**RE: Transfer Station Design Revision
Dunn-Erwin Landfill, Permit 43-07T
(via email & hardcopy)**

On behalf of Harnett County, we submit the following seeking approval to amend the previously approved design for the tipping floor of the Dunn Erwin Transfer Station:

Sheet Title: BULLETIN #15
 Date: 10/7/13 Sheet
 Scale: AS NOTED **2.2.2A**
 OF 6

FLOOR DEMOLITION PLAN
 SCALE: 1" = 10'

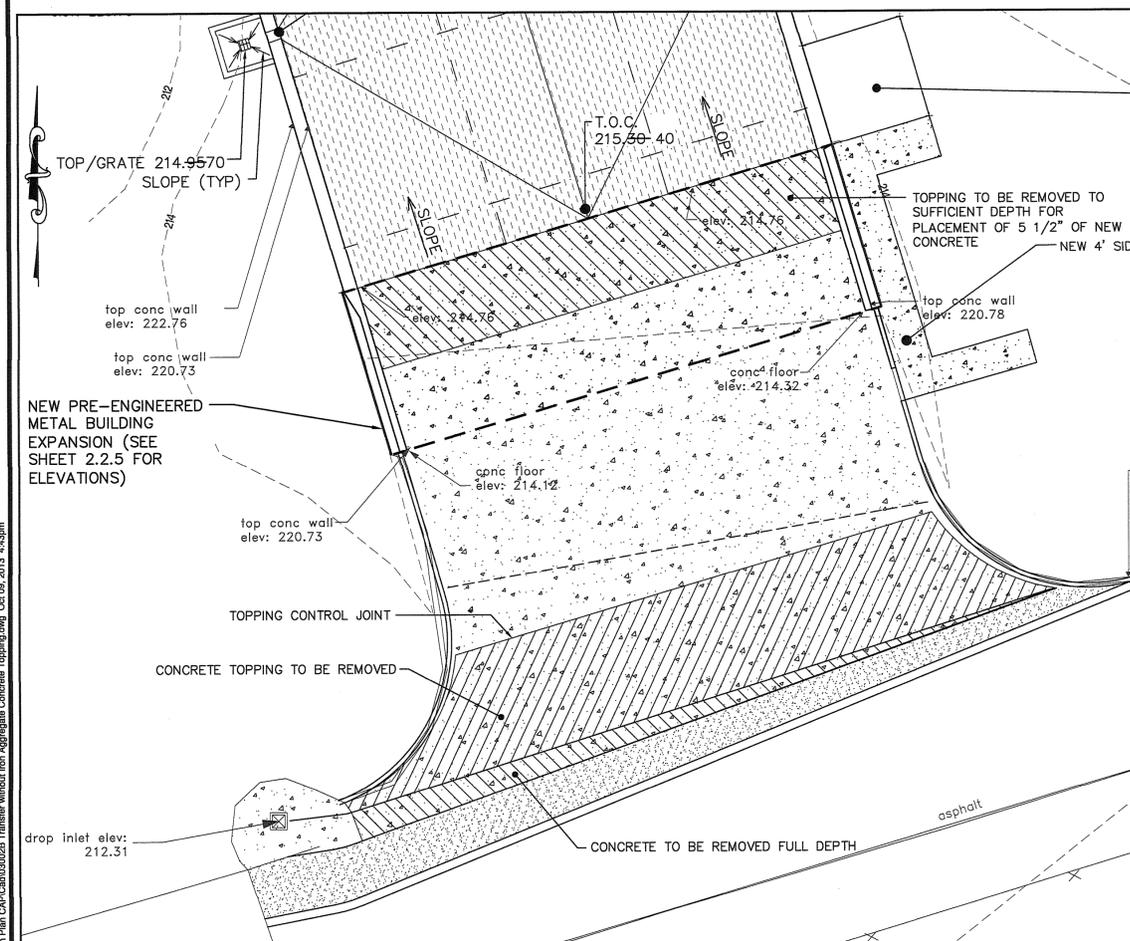
1. Removal/abandonment of the exterior leachate collection drain that previously collected runoff from the concrete approach apron where liquid adhering to tires leaving the transfer station was tracked.
2. The tipping floor is being extended to the edge of the new building extension.
3. The proposed floor grades associated with this change direct all drainage from the tipping floor to the internal building leachate drains.
